**RE: Delaware River Solar, LLC
Solar Energy Facility
466 Yellow Mills Road
Response to Town Engineer Comments**

Delaware River Solar, LLC
Solar Energy Facility
Response to Planning Comments

DRAINAGE CALCULATIONS CULVERT CROSSING

TCH LINE: SHEET S-2

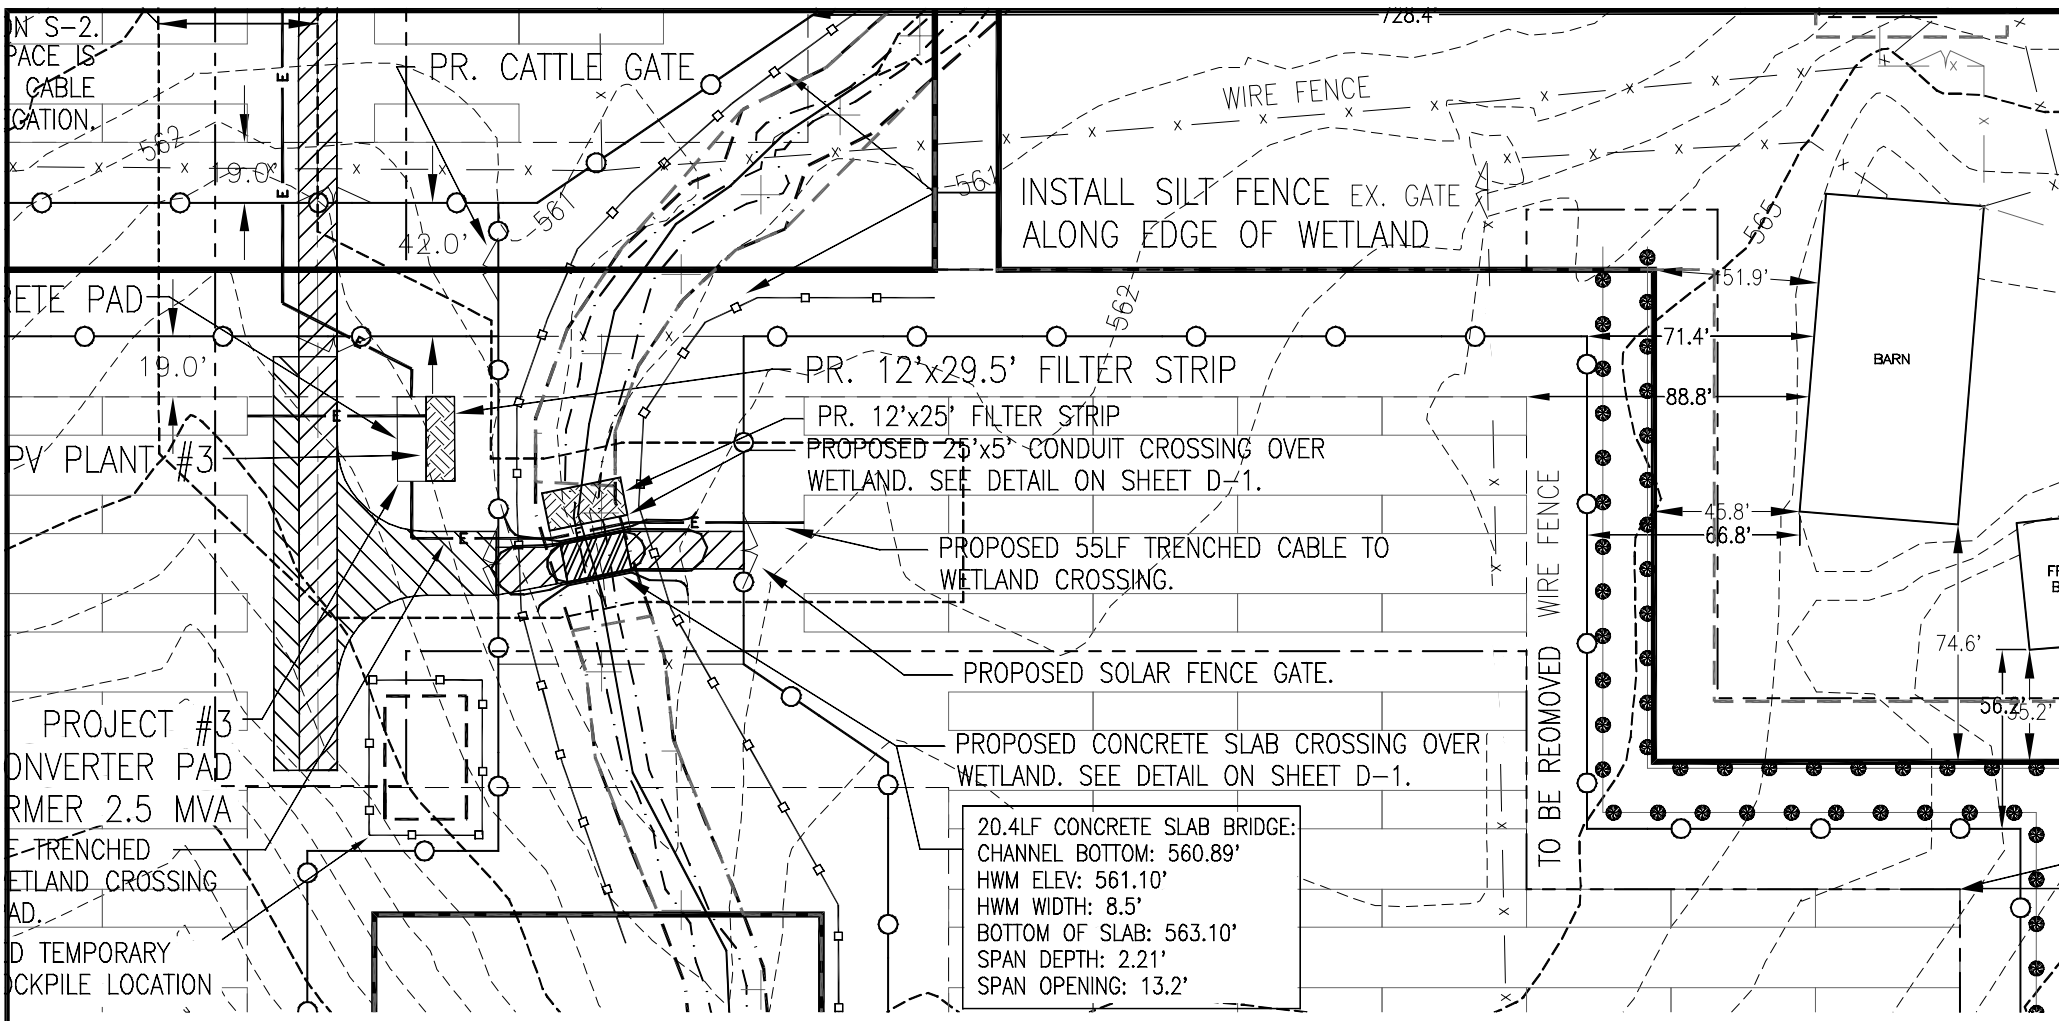
3. The increase in impervious surfaces due to the proposed culvert will be addressed in the same manner as the concrete equipment pads and the limited use pervious access road. A 12'x25' filter strip is provided downslope of the crossing to account for the impervious concrete slab. Utilizing the limited use pervious access for the culvert approach allows the roadway to be considered as pervious in the calculations. The SWPPP has been revised to add the 0.005 acres to the Impervious Areas of the Post Development Conditions (Section 4.1.D_Subcatchment 2S – Post-Development Summary). There was no impact to the results of the calculations. There will be no permitting required for the installation of the culvert as the wetland plus 25% of its width will not be impacted by its installation.
